P04 Outcome of Technical Review and Recent Progress

David Stuart, UC Santa Barbara Fermilab Director's Review 19 March 2019

Technical Review committee: Jarek Kaspar, U. Washington Mitch Newcomer, U. Pennsylvania Mark Oreglia, U. Chicago Rob Roser, Fermilab (chair)

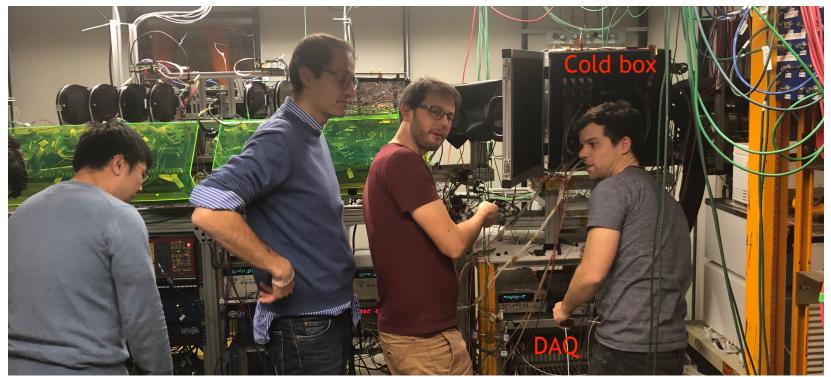
\checkmark ETL-R1: It is crucial to follow the schedule of beam test and/or system integration tests to verify functionality of the LGAD/ROC/Back-end systems

- We are planning a series of tests aimed at each major development stage
- Will examine the mechanical, thermal, and electrical performance of modules
- Will use realistic backend electronics as it becomes available
- Test full sensor-to-DAQ chain with multiple modules
- Beam tests to verify the production modules.

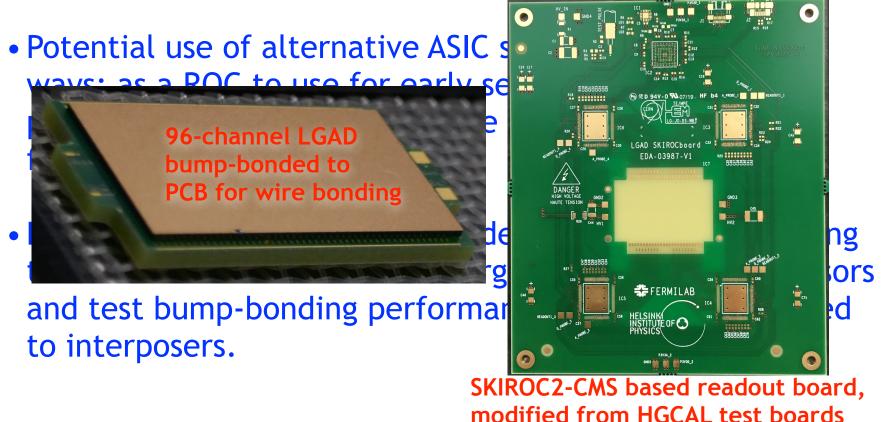
- ✓ETL-R2: Identify alternative ASIC solutions from existing or potentially viable prototypes of other systems, and create a decision matrix for breakpoints in the ETLROC development in case that device falls behind in the development schedule or fails to function as required.
- Potential use of alternative ASIC solutions comes in two ways: as a ROC to use for early sensor and module prototyping, and as a ROC to use for production of the final detector.
- For early prototyping, we have designed test boards using the SKIROC2 ASIC to read out large prototype LGAD sensors and test bump-bonding performance with sensors bonded to interposers.
